Executive Director's Recommendation

PROJECT Consolidated Planned Unit Development and Related Map Amendment at Square 744S and 744SS (DC Water) O Street Pumping Station Bound by N Pl. SE, Canal St. SE, private property, and the Anacostia River	NCPC FILE NUMBER ZC 15-14
SUBMITTED BY Zoning Commission of the District of Columbia	NCPC MAP FILE NUMBER 41.11(06.00)44278
REVIEW AUTHORITY Approval of Comments to the Zoning Commission of the District of Columbia	APPLICANT'S REQUEST Approval of report to the Zoning Commission of the District of Columbia
	PROPOSED ACTION Approve as requested
	ACTION ITEM TYPE Consent Calendar

ZC 15-14

Consolidated PUD & Related Map Amendment

ROOF TERRACE SECTION

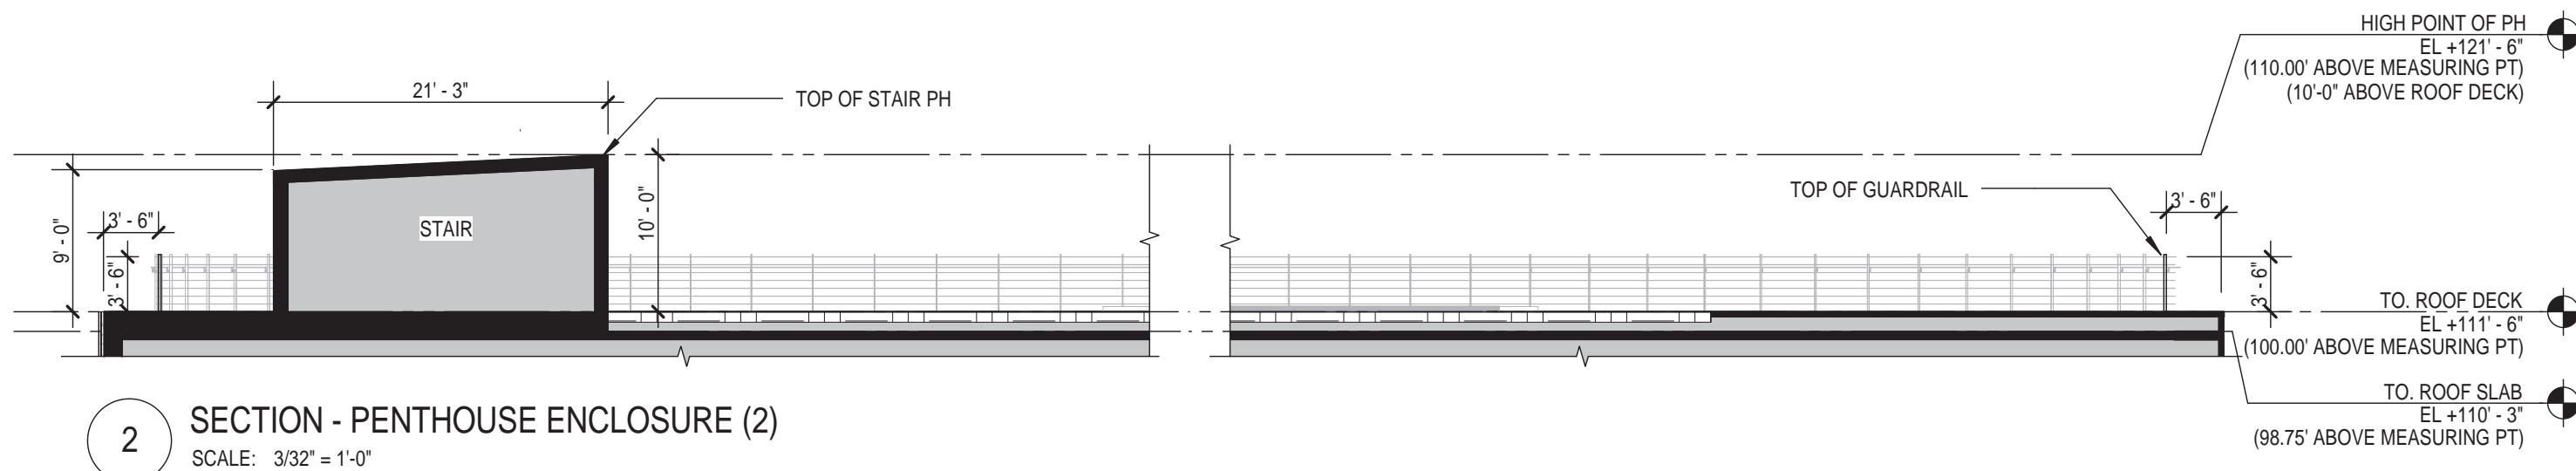
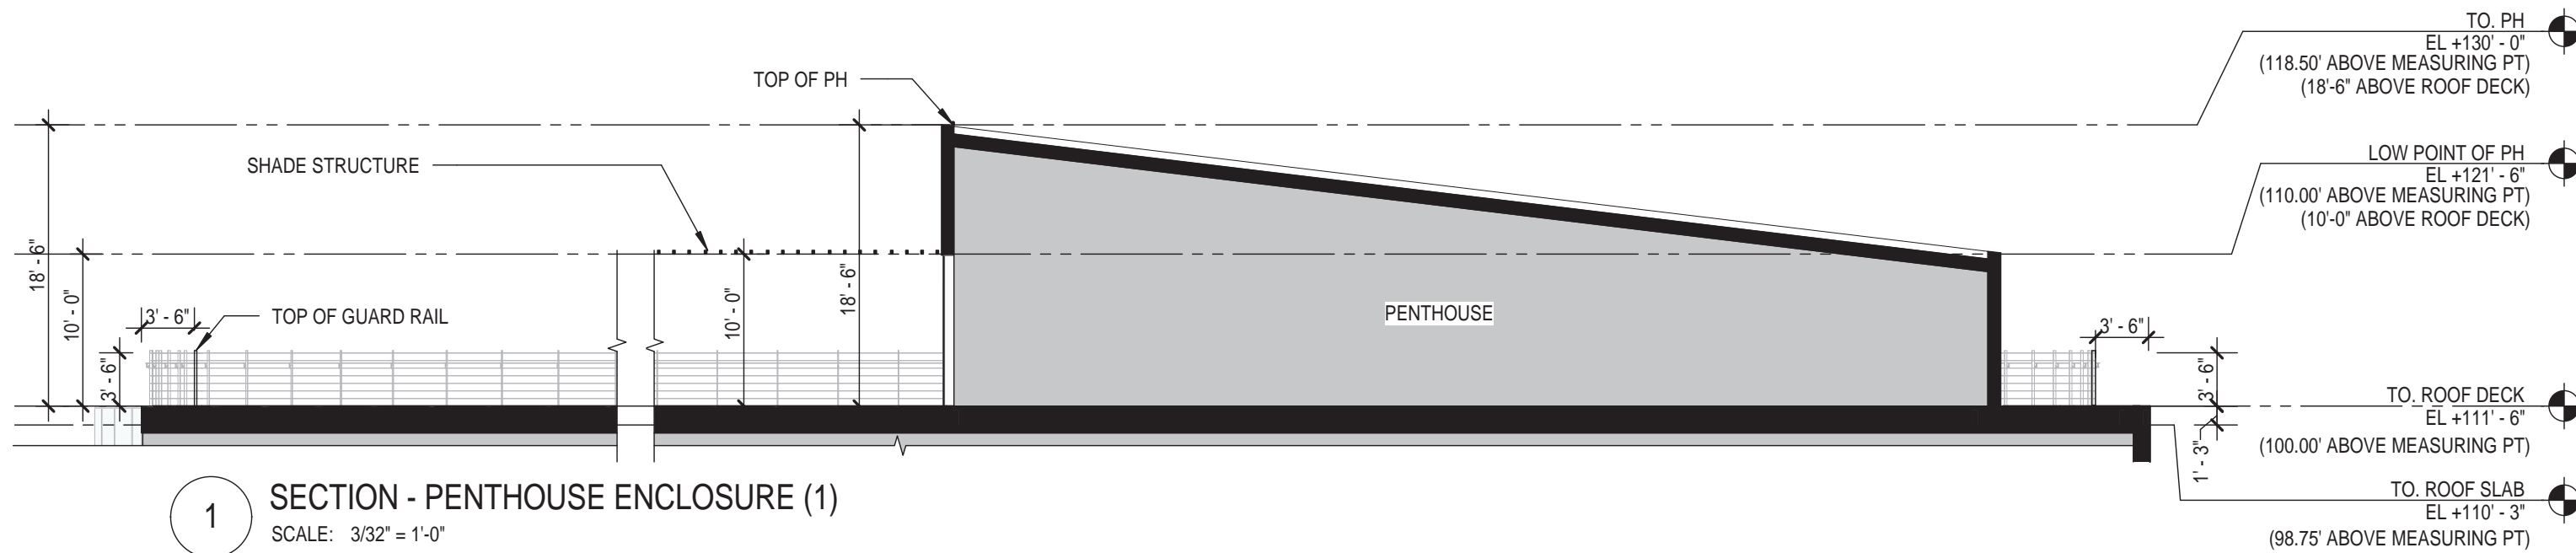
- The Consolidated PUD's proposed height of 100 feet is at the allowable height under the Height of Buildings Act (Height Act) feet based on the 80-foot right-of-way width of Canal Street SE. On December 21, 2015, the applicant provided revised drawings to the Zoning Commission that eliminated a proposed parapet that exceeded the allowable height under the Height Act; the revision now includes a continuous 3'6"-high guardrail that is set back from the roof edge at a 1:1 ratio, which conforms to Height Act requirements.
